Access Compliance Report Public Rights-of-Way (Curb Ramps)

Intersection ID: 50592 Main Street: BENDING_BRANCH_RD Cross Street: BRISTLEY_RD Location: SW

ADA ID: 14B94E855711 Ramp Type: Perp Initial Pass/Fail: Fail Overall Compliance: No Severity Score: 12.5

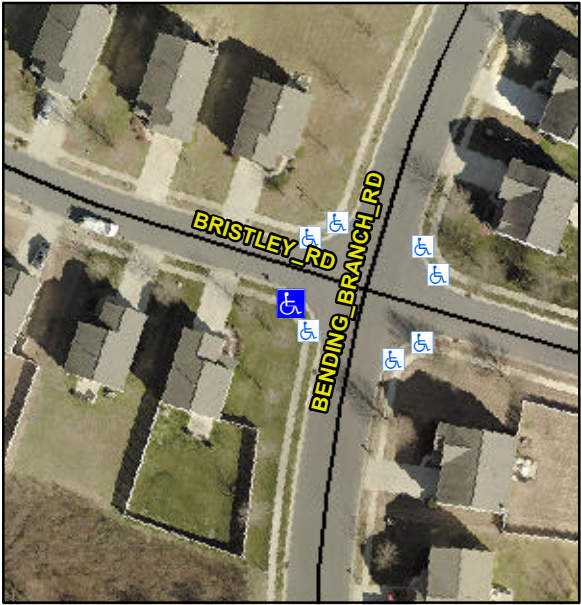
PROW/ADA:
Not Found, R304.5.3

Compliance	Description	Data	Compliance	Description	Data
N/A	Ramp Length (in)	48.5	Yes	Ramp Slope (%)	7.7
Yes	Ramp Width (in)	48.0	No	Ramp XSlope (%)	5.6
N/A	Flare Type LT	N/A	N/A	Flare Type RT	N/A
N/A	Flare Slope LT (%)	N/A	N/A	Flare Slope RT (%)	N/A
N/A	Flare Traversable LT?	N/A	N/A	Flare Traversable RT?	N/A
N/A	Landing Length (in)	N/A	N/A	DWS Provided?	N/A
N/A	Landing Width (in)	N/A	N/A	DWS Contrast?	N/A
N/A	Landing Slope (%)	N/A	N/A	DWS Length (in)	N/A
N/A	Landing X Slope (%)	N/A	N/A	DWS Full Width?	N/A
N/A	Landing Curb? (Y/N)	N/A	N/A	DWS Offset (in)	N/A
N/A	Shared Landing?	N/A			
N/A	Gutter Ponding?	N/A	N/A	Gutter Slope (%)	N/A
N/A	Gutter Lip Ht (in)	N/A	N/A	Gutter X Slope (%)	N/A
N/A	Painted X Walk1?	No	N/A	Painted X Walk2?	N/A
	X Walk 1 Direction	To N		X Walk 2 Direction	N/A
N/A	X Walk 1 Width (in)	N/A	N/A	X Walk 2 Width (in)	N/A
	X Walk 1 Slope (%)	1.4		X Walk 2 Slope (%)	N/A
	X Walk 1 X Slope (%)	4.0		X Walk 2 X Slope (%)	N/A

N/A	Ramp inside XWalk1?	N/A	N/A	Ramp inside XWalk2?	N/A
	Road Slope (%)	N/A	N/A	Clear Space?	N/A
	Road X Slope (%)	N/A	N/A	Clear Space to XWalk (in)	N/A
N/A	Any Obstructions?	N/A	N/A	Storm Grate/Utility Hazard?	N/A
	Obstruction Type			Storm Grate/Utility Type	
			N/A		N/A
			Yes	Surface Condition? (G/P)	Good

Possible Solutions:
Remove & Replace Entire Ramp.
